WATER LICENCE INSPECTION FORM

Licensee	Licensee Representative
2AM-MEL1631	Alexandre Gauthier, Justin MacMillan
Licence No. / Expiry	Representative's Title
July 21st, 2024	AEM Environment
Land / Other Authorizations	Land / Other Authorizations
IOL	2BW-MEL1524, 2BB-MEL1424
Date of Inspection	Inspector
May 25 <sup>th</sup> , 2016	WRO C. Wilson
Activities Inspected	
<input type="checkbox"/> Camp	<input type="checkbox"/> Drilling
<input checked="" type="checkbox"/> Roads/Hauling	<input type="checkbox"/> Mining
	<input checked="" type="checkbox"/> Construction
	<input checked="" type="checkbox"/> Other: Water Discharge
	<input checked="" type="checkbox"/> Other: Culverts
	<input type="checkbox"/> Reclamation
	<input type="checkbox"/> Fuel Storage

AGNICO EAGLE MELIADINE GOLD PROJECT

Locations name:  
Photo 10

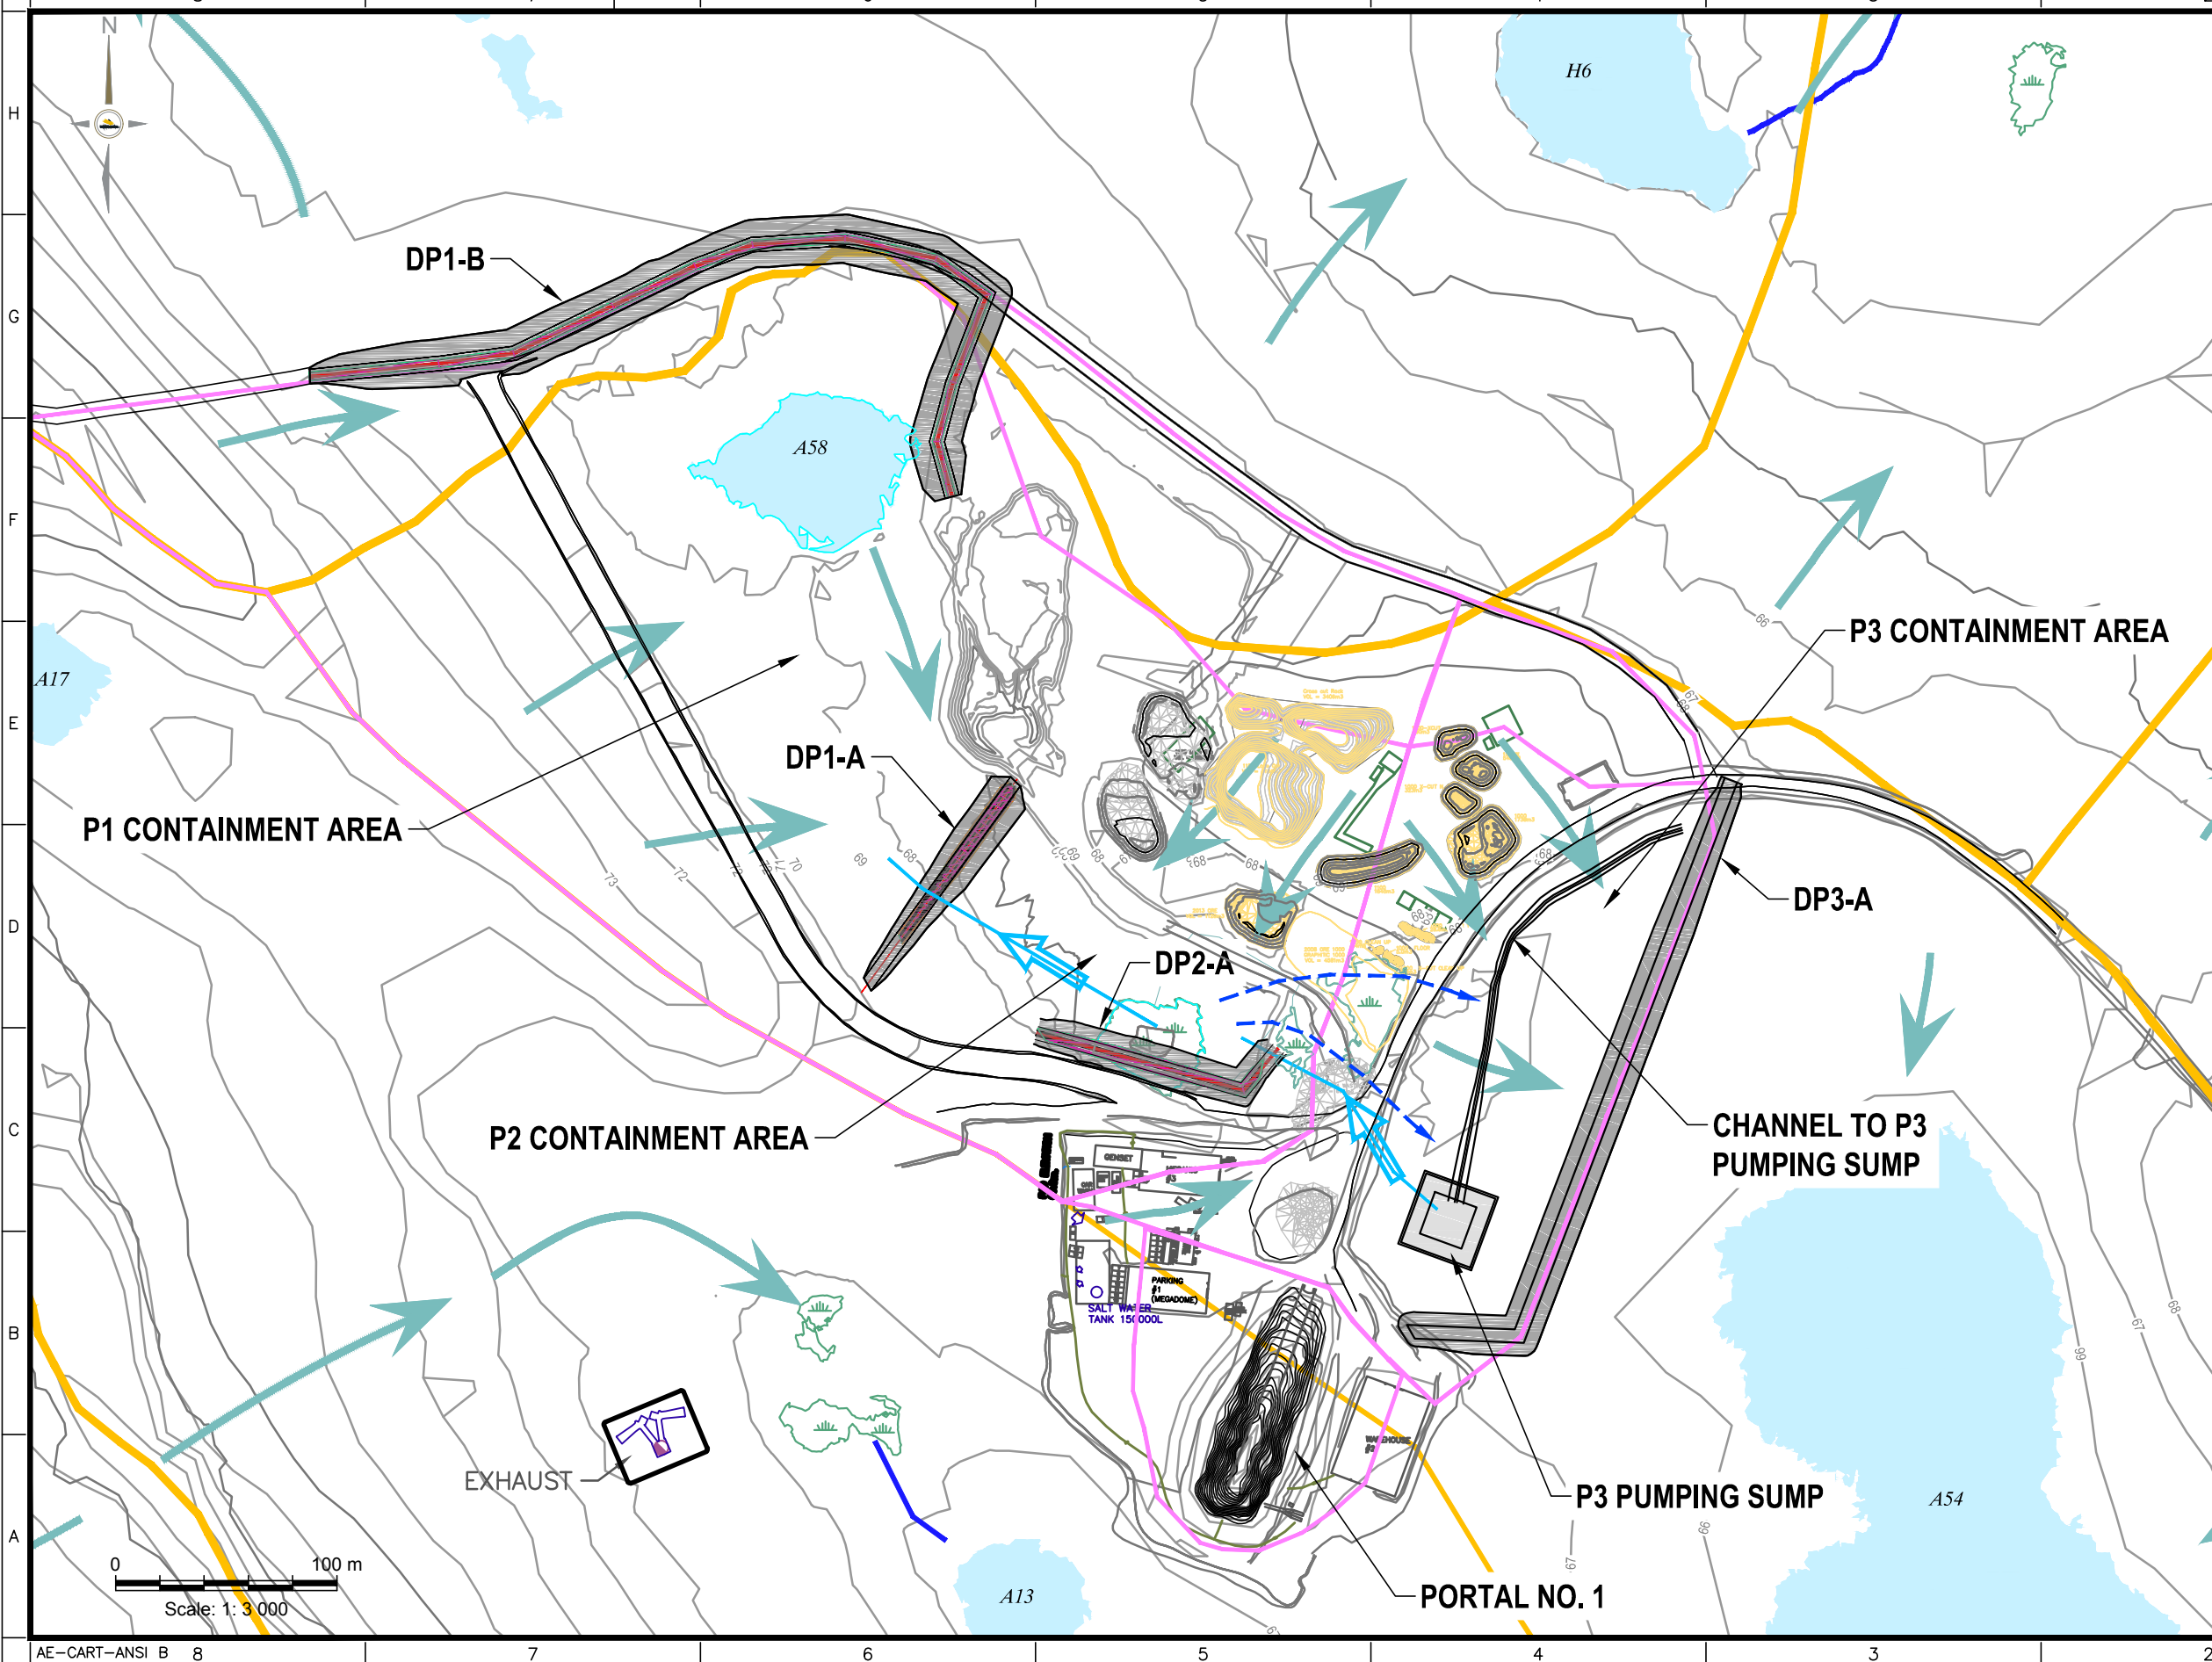
SECTION 2	<input type="checkbox"/> Comments (s. 1)	<input checked="" type="checkbox"/> Non-Compliance with Act or Licence (s. 2)	<input type="checkbox"/> Action Required (s. 3)
<p>— The Licensee is reminded that pursuant to part E item 6, deposit of sediment into <u>any water body</u> is prohibited. Materials are to be located at a minimum of thirty one (31) meters from the ordinary high water mark. <b>"High water mark"</b> as defined by the licence, means the usual or average level to which a body of water rises at its highest point and remains for sufficient time so as to change the characteristics of the land (ref. Department of Fisheries and Ocean, Operational Statement: Mineral Exploration Activities);</p> <p>— The Licensee is reminded, pursuant to part E item 12, activities shall be conducted in such a way to minimize impacts on surface drainage and the licensee shall immediately undertake any corrective measures in the event that surface drainage is impacted.</p>
